Project	<b>IEEE 802.16 Broadband Wireless Access Working Group</b> < <a href="http://ieee802.org/16">http://ieee802.org/16</a> >
Title	<b>Amendment to Security Primitives in Section 14.2.2.1, 14.2.2.2</b>
Date Submitted	<b>2007-03-08</b>
Source(s)	Jung-Mo Moon, JeeHyeon Na, Mi-Young Yun, and Sangho Lee <a href="mailto:jhna@etri.re.kr">jhna@etri.re.kr</a>  ETRI  161 Gajeong-dong, Yuseong-gu Daejeon 305-700 Korea
Re:	Contribution on comments to IEEE 802.16g/D8
Abstract	Re-definition of RSA primitives in section 14.2.2.2
Purpose	Adoption
Notice	This document has been prepared to assist IEEE 802.16. It is offered as a basis for discussion and is not binding on the contributing individual(s) or organization(s). The material in this document is subject to change in form and content after further study. The contributor(s) reserve(s) the right to add, amend or withdraw material contained herein.
Release	The contributor grants a free, irrevocable license to the IEEE to incorporate text contained in this contribution, and any modifications thereof, in the creation of an IEEE Standards publication; to copyright in the IEEE's name any IEEE Standards publication even though it may include porti

Figure XXX – RSA based Authentication Procedure in MS

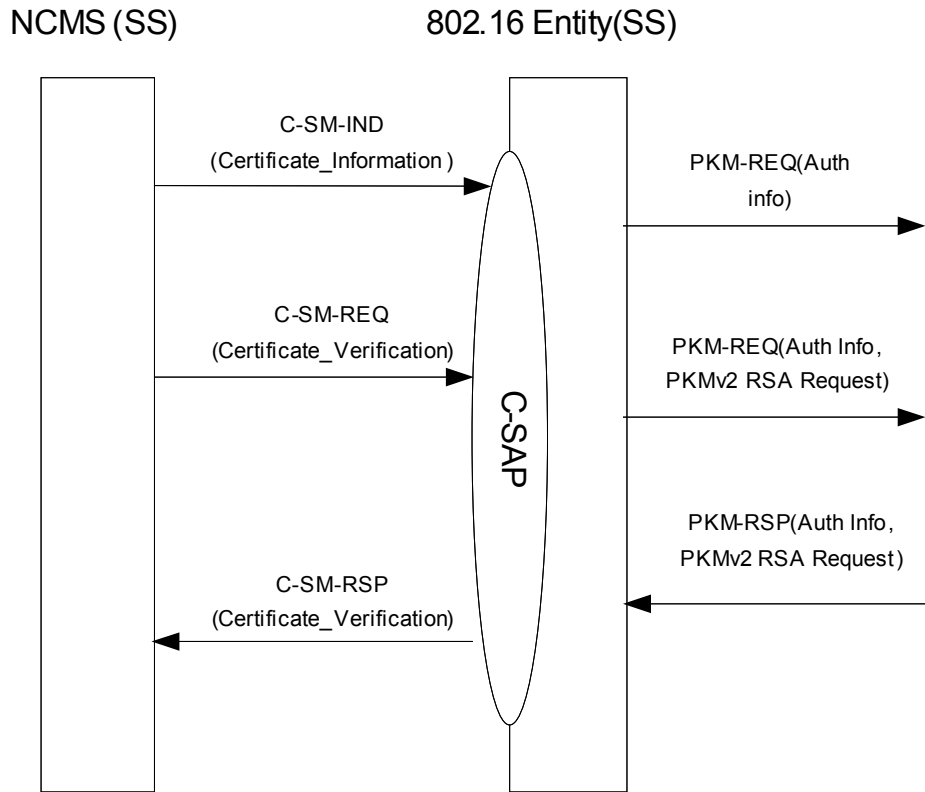
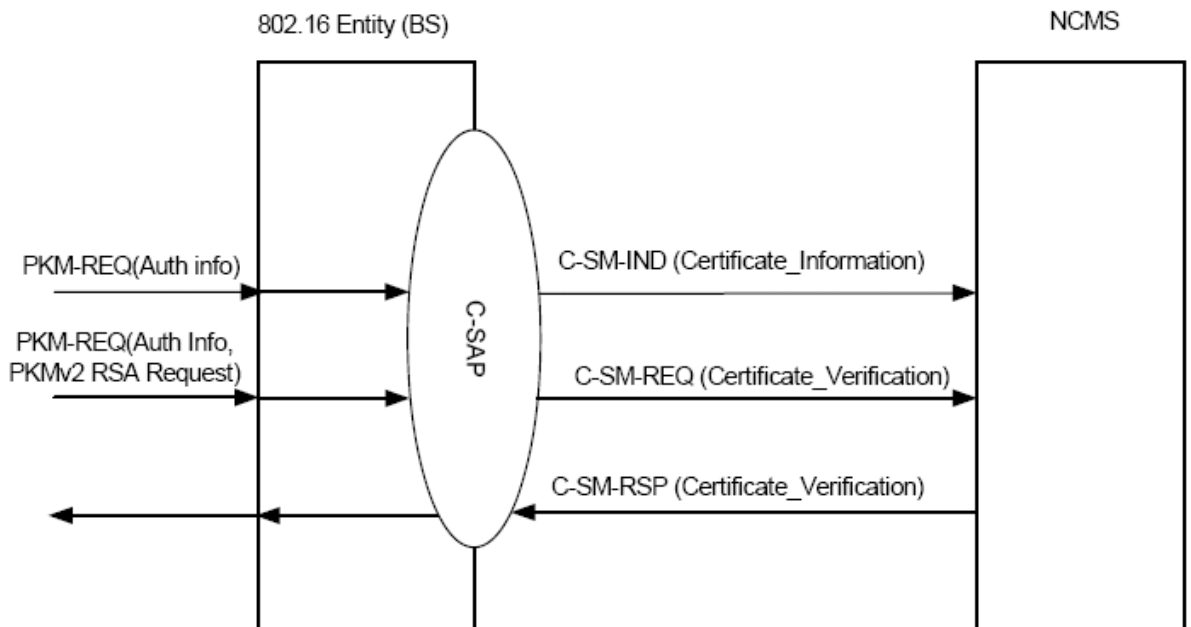
1. add a figure to illustrate security primitives on MS side.
2. change each subsection to clarify and describes on each side (SS(MS) and BS side)

Figure XXX and 474 shows a RSA-based authentication procedure between an 802.16 entitita BS and the NCMS entity as follows:

[Insert the figure XXX to the following figure Section 142.2.1]
